MULTIPLE MIRROR TELESCOPE OBSERVATORY

MMTO Internal Technical Memorandum 86-4

Re: Grounding System for Steward Observatory Building

Date: May 6, 1986

Figure 1

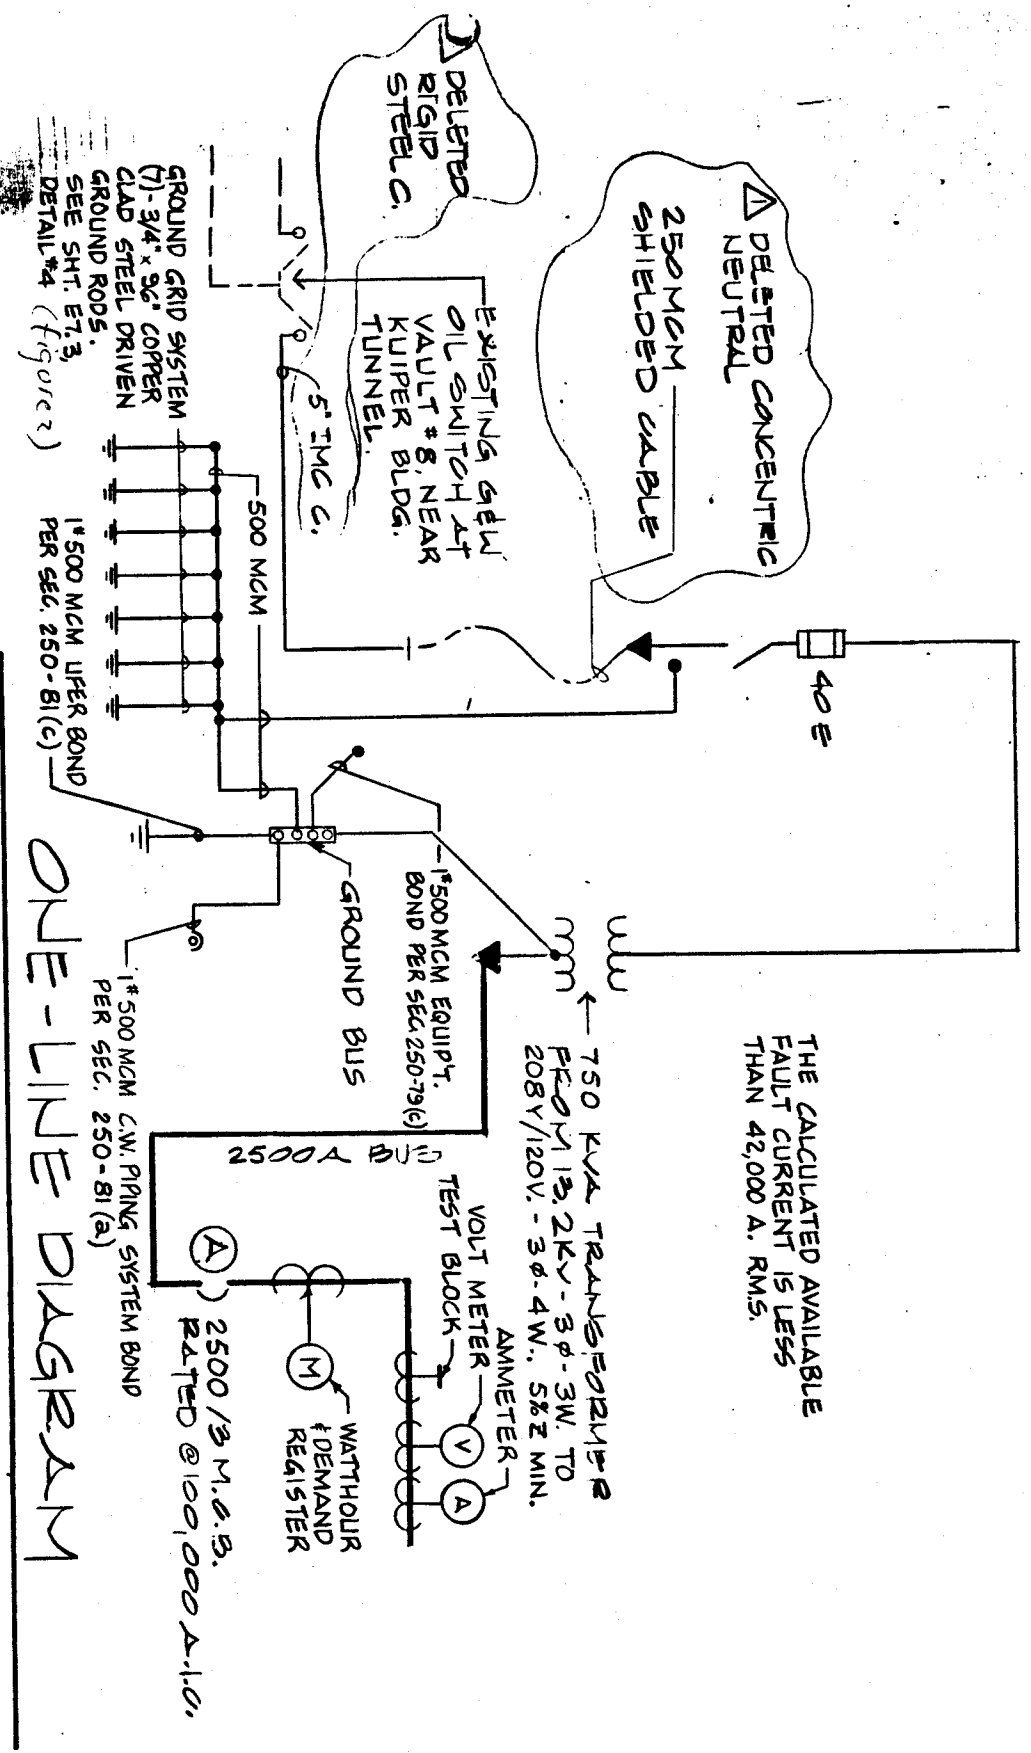
From my experience, I would rate the "isolated ground" as seriously compromised for the following reasons:

1. I don't think jacks provide a suitable low ohmic contact.
2. The ground wire is too small.
3. The connection to earth ground is inadequate and not serviceable.
4. The connection between wires in the isolated ground are twist locks which I don't think provide a suitable low ohmic connection.
5. This ground should connect to the grid shown in Figure 1.

Where an equipment ground is required, I suggest a connection to a water pipe or in extreme cases, running a 2" or larger braid to the ground shown in Figure 1.

Figure 3

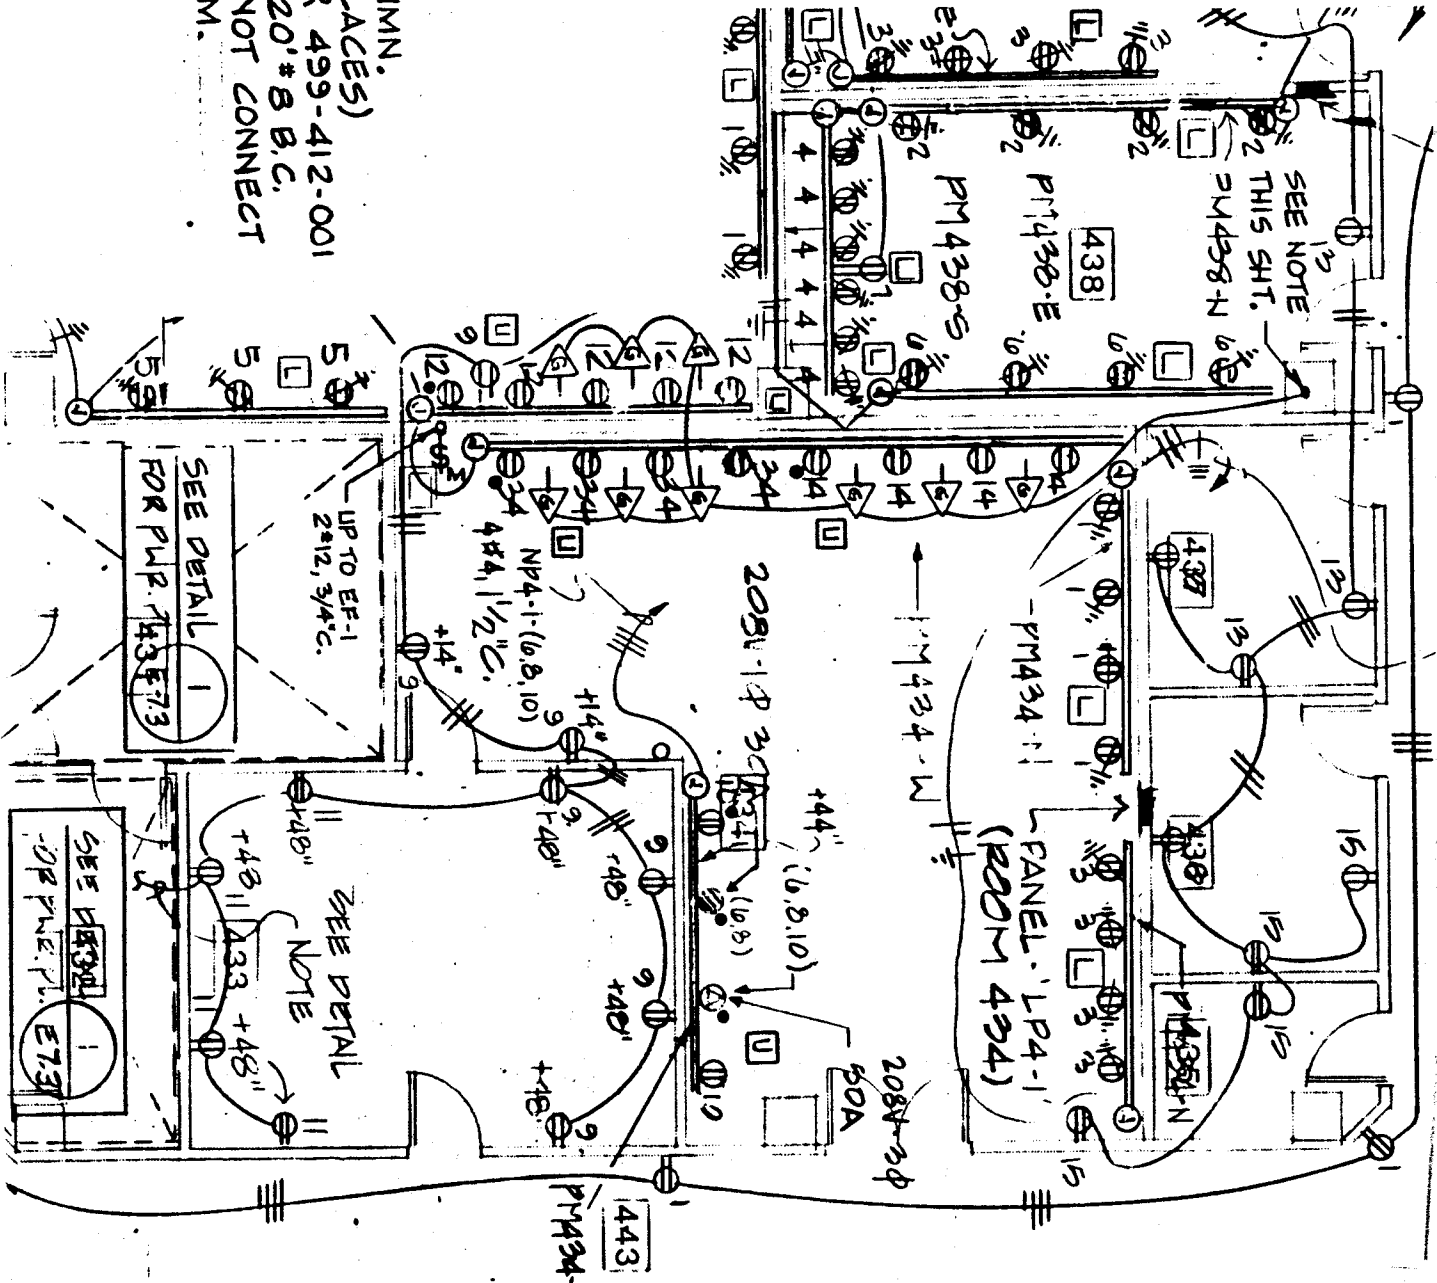
Green-colored jacks in the electronics shop labelled "isolated ground" connect via a #8 wire to earth ground consisting of a coil of bare copper #8 wire under the building foundation. This ground does not connect to the grounding system in Figure 1 or 2 other than through the earth. Plugs for the isolated ground system are available in the Steward electronics shop.
